ADDENDUM

PROJECT:	La Vista City Centre South MU – Lot 15	**PROJECT NO.:**	F16132
TO:	Prospective Bidders	**DATE:**	05/04/2017
FROM:	BVH Architecture	**ADDENDUM NO.:**	#2

1 04-FOURTH FLOOR - PLUMBING

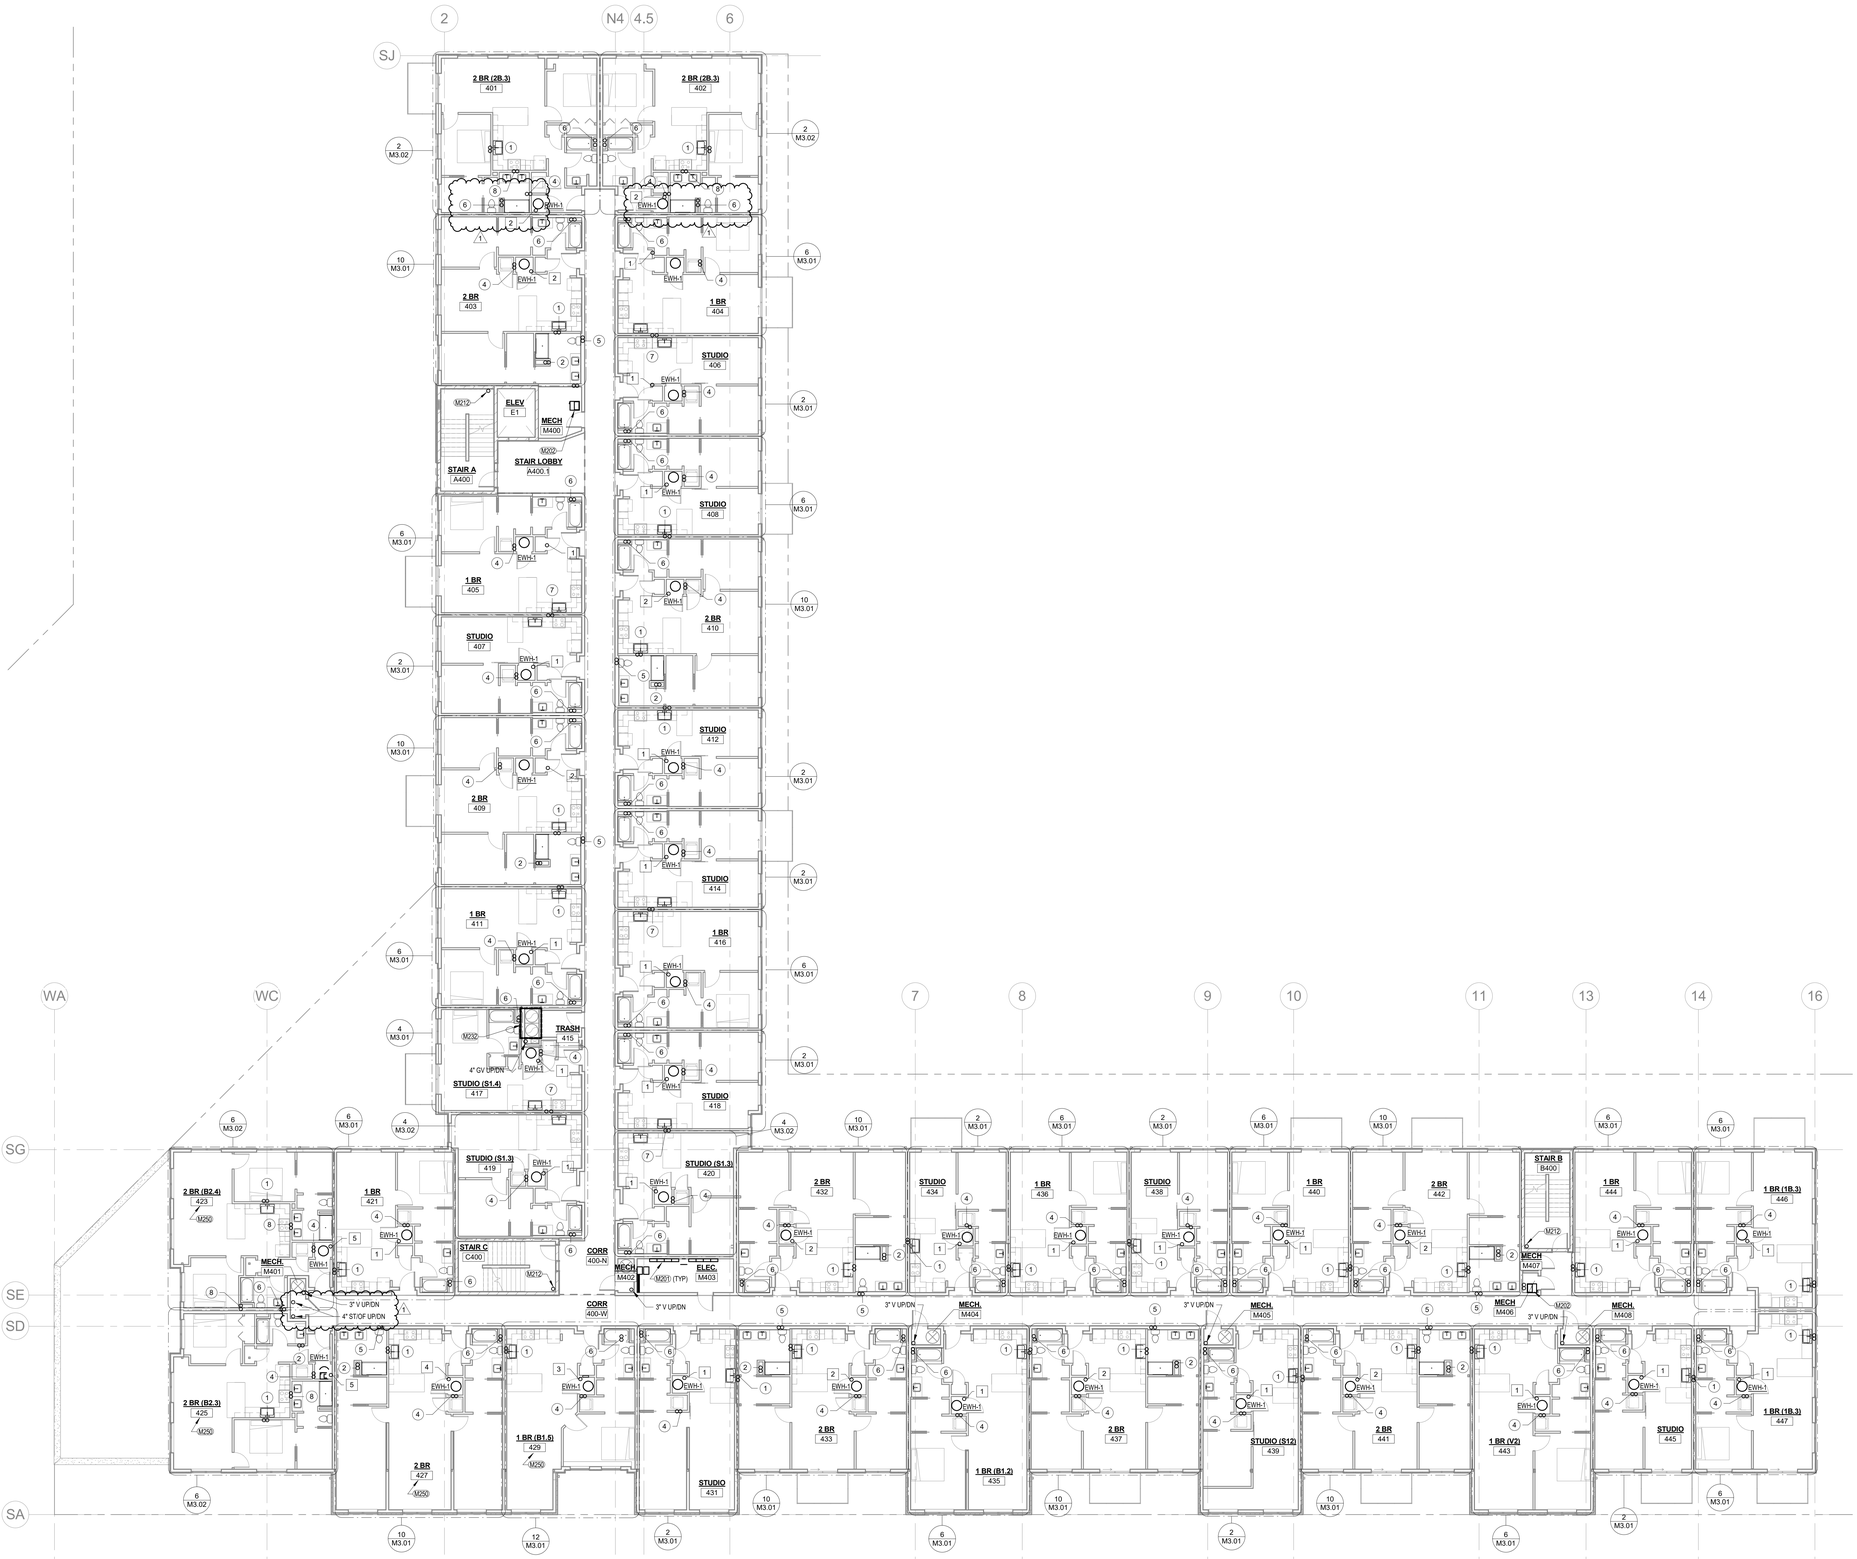
9. Sheet M2.04 – Fourth Floor – Plumbing
    a. See plan revisions
10. Sheet M2.05 – Fifth Floor – Plumbing
    a. See plan revisions
11. Sheet M2.06 – Sixth Floor – Plumbing

1 **06-SIXTH FLOOR - PLUMBING**

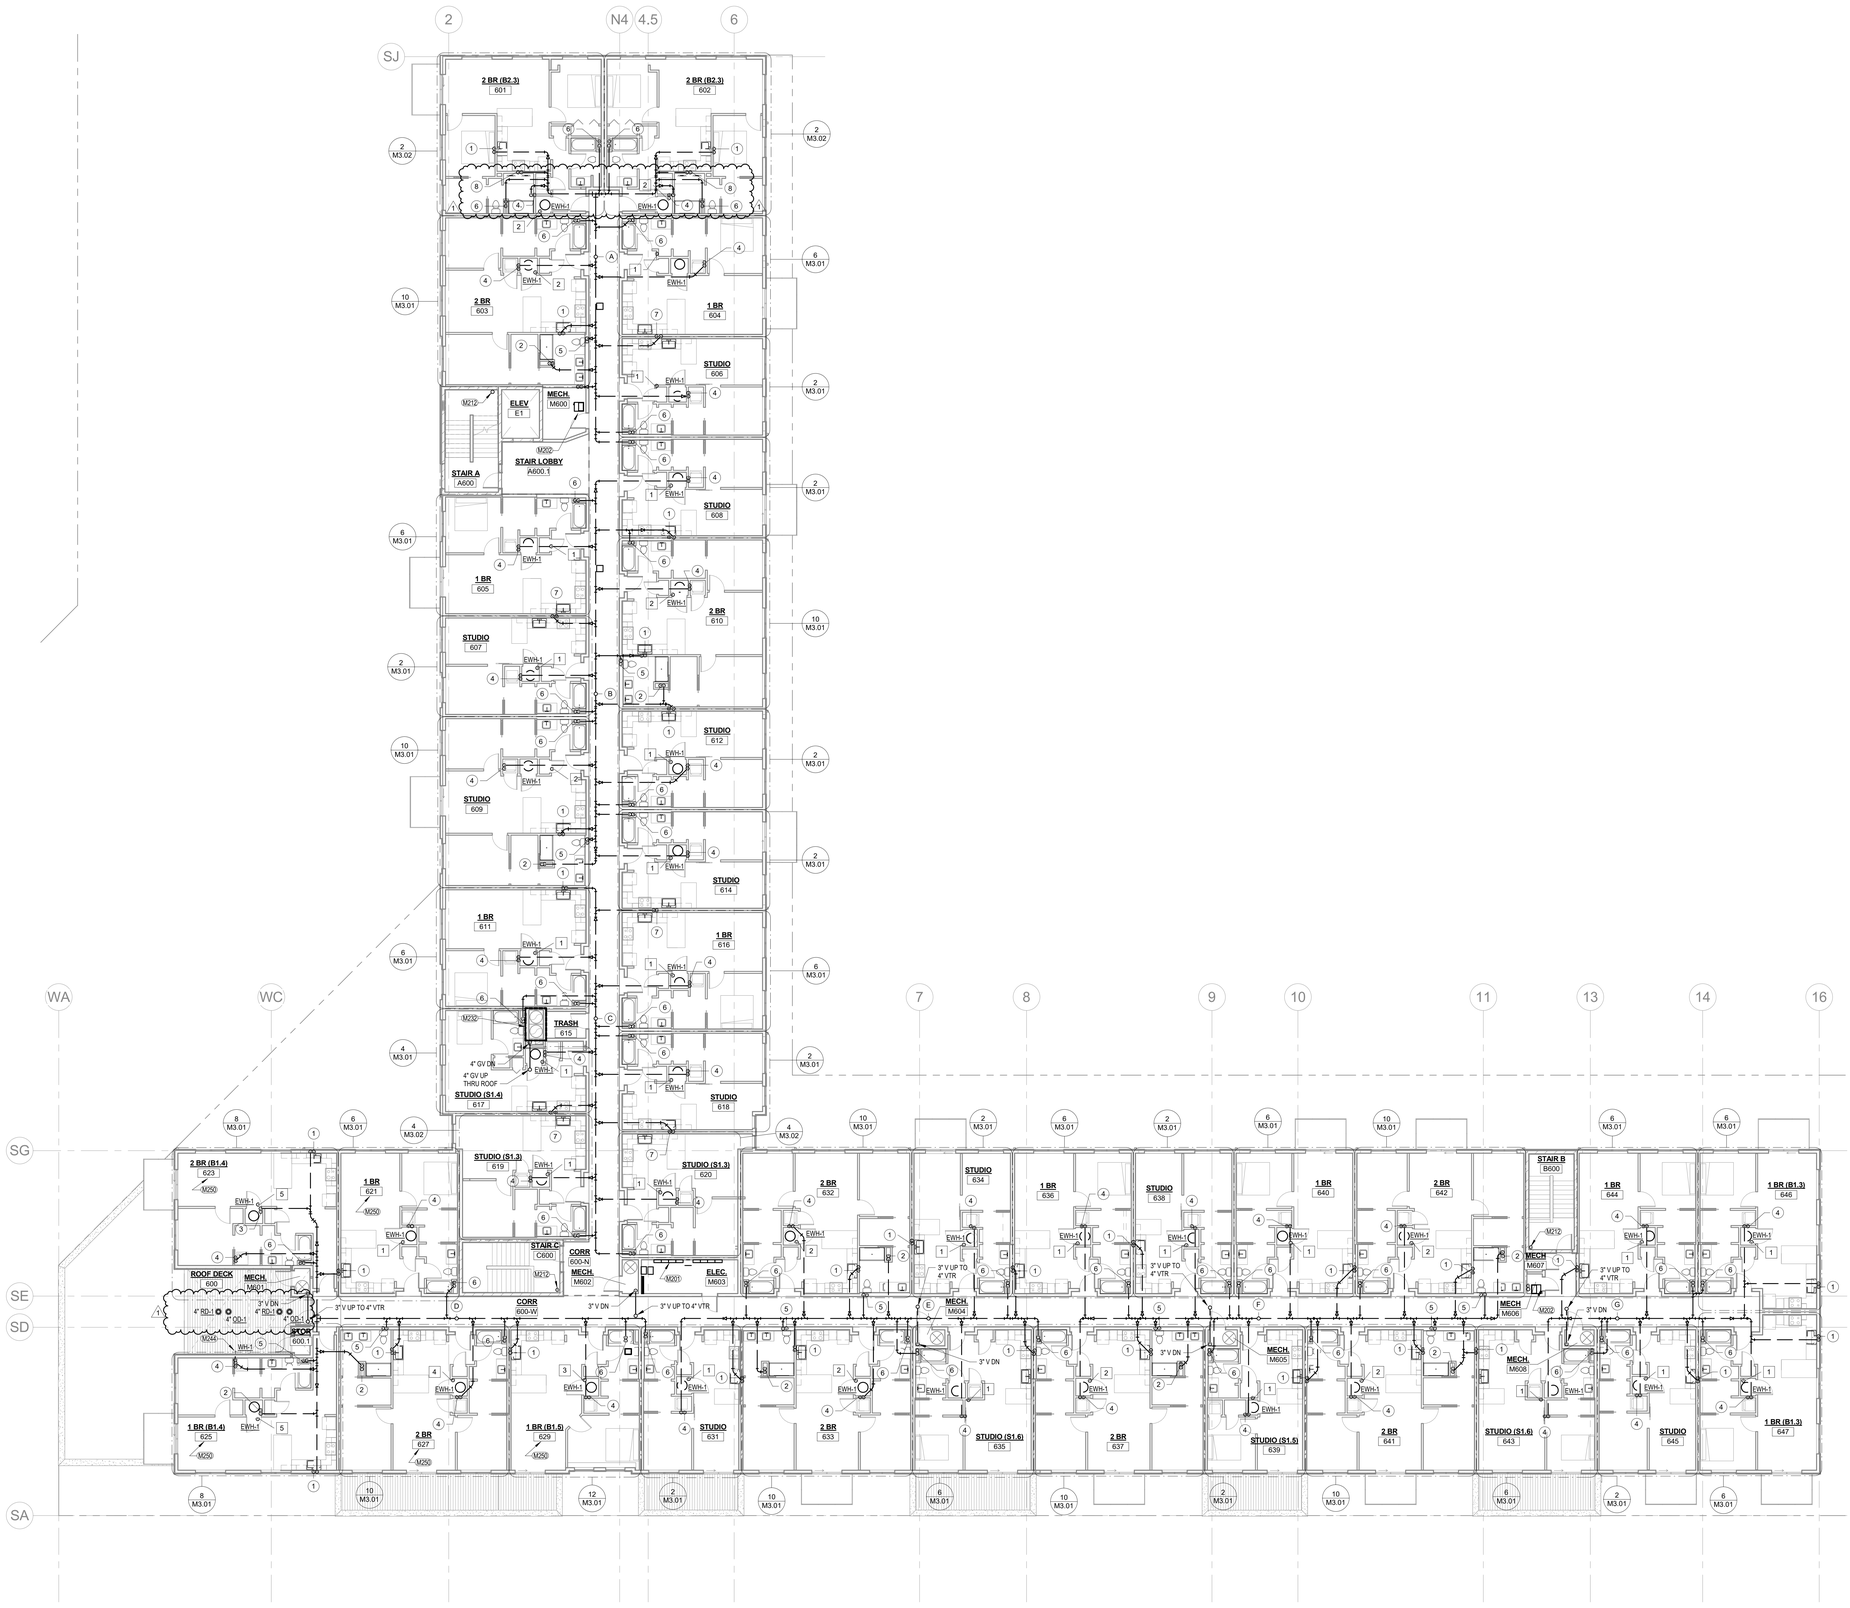
a. See plan revisions
12. Sheet M6.01 - Mechanical Schedules
    a. See plan revisions.

1 **GROUND FLOOR - SPECIAL SYSTEMS**
3/32" = 1'-0"

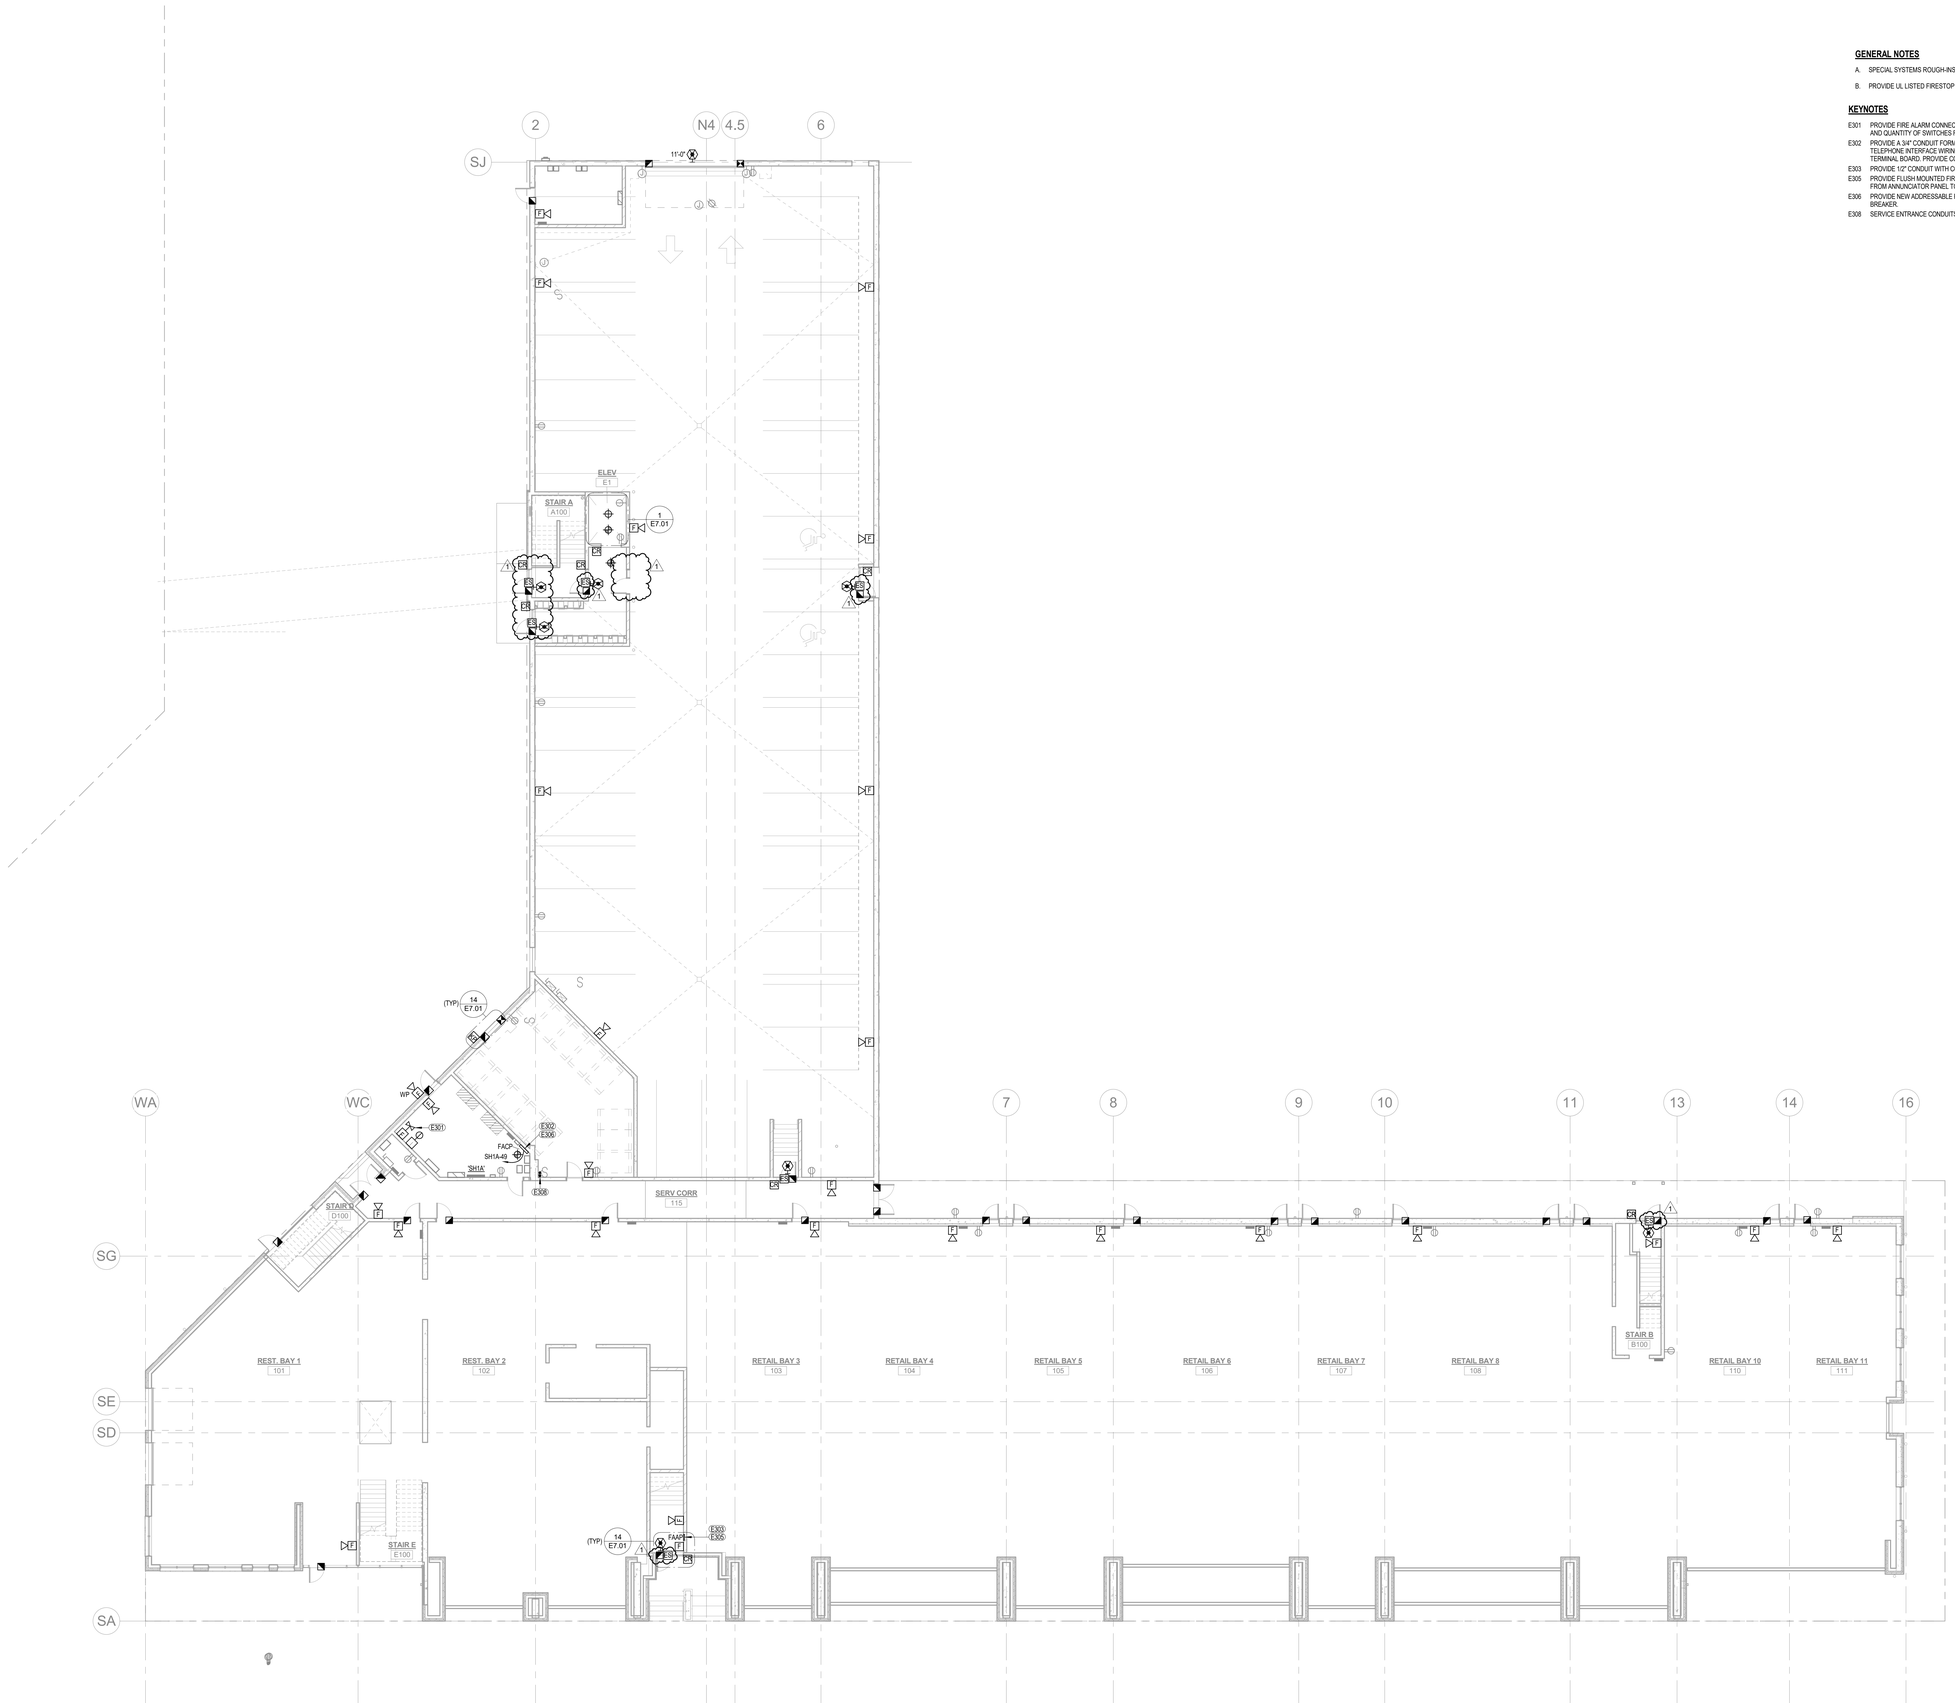
2. Sheet E3.01 – Ground Floor – Special Systems
    a. Door B100 – Revise power transfer hinge to electric strike.
    b. Door C100.1 – Revise power transfer hinge to electric strike.
    c. Door 120.1 – Revise power transfer hinge to electric strike.
    d. Door A100.1 – Revise power transfer hinge to electric strike.
    e. Door A100.3 – Remove card access rough-ins.
    f. Door A100.2 – Add card access rough-ins.
    g. Door A100.4 – Add card access rough-ins.
